RE: Penrith Lakes Employment Lands Subdivision Construction Phase Flood Emergency Response Sub-Plan

Penrith Lakes Employment Lands Subdivision Construction Phase Flood Emergency Response Sub-Plan

Table a: Response to Agency Comments

Figure 1: Flood Emergency Response Phases and Actions

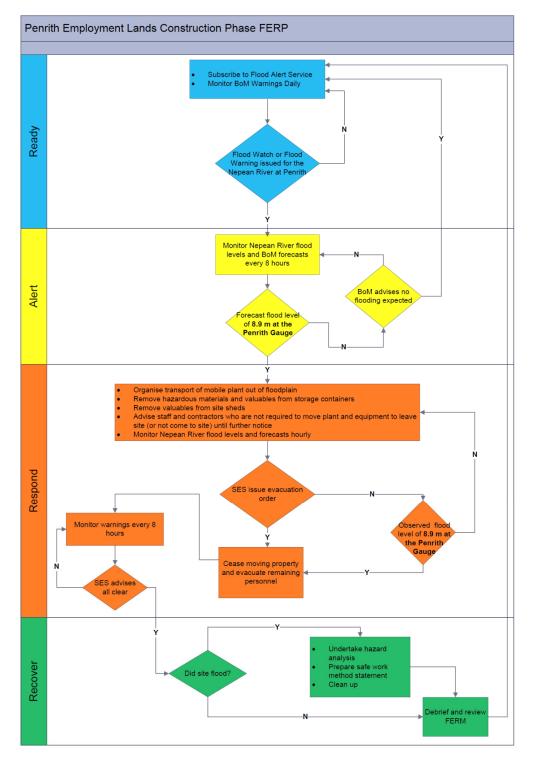
Figure 1 is a flow diagram showing the flood emergency response procedures before, during and after a flood for the construction phase of the development (as per DA condition C18.(d)(i)). There are four phases:

Figure 2: Flood Evacuation Routes

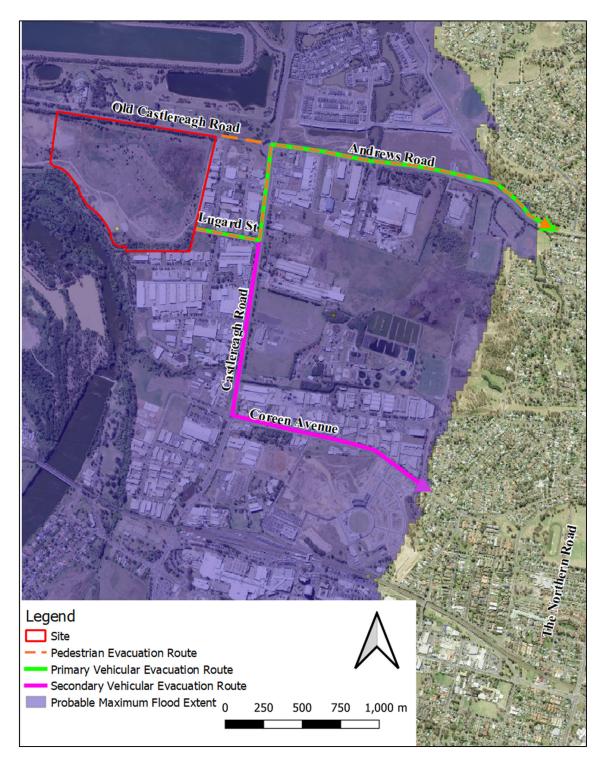
the SES and other emergency response		
agencies must prevail over the measures		
outlined in the FERSP.		
NSW SES – 8 September 2023		•
Andrews Road should be the primary	This has been clarified by adding text	7, 10
evacuation route for the site construction	and updating Figure 2.	
staff and Coreen Avenue can be used as		
		I

[]
secondary evacuation route. For evacuation		
traffic management purposes when exiting		
Lugard Street it is preferable to turn left on to		
Castlereagh Road towards the roundabout		
rather than turning right heading south		
towards flooding on Boundary Creek.		
The following comments apply to the eventual	site configuration, noting that the DA wo	is approved
after the relevant Land and Environment court	decision.	
Principle 1. Any proposed Emergency	The FERSP has been designed to be	2
Management strategy for an area should be	consistent with the NSW SES	
compatible with the evacuation strategies	evacuation strategy and the	
identified in the relevant local or state flood	Hawkesbury-Nepean Valley Flood	
plan or by the NSW SES.	Emergency Plan 2020. This has been	
	clarified in the text.	
Principle 1. It is unclear what the triggers	Pedestrian evacuation is only to be	6, 7
	undertaken should vehicular	0, /
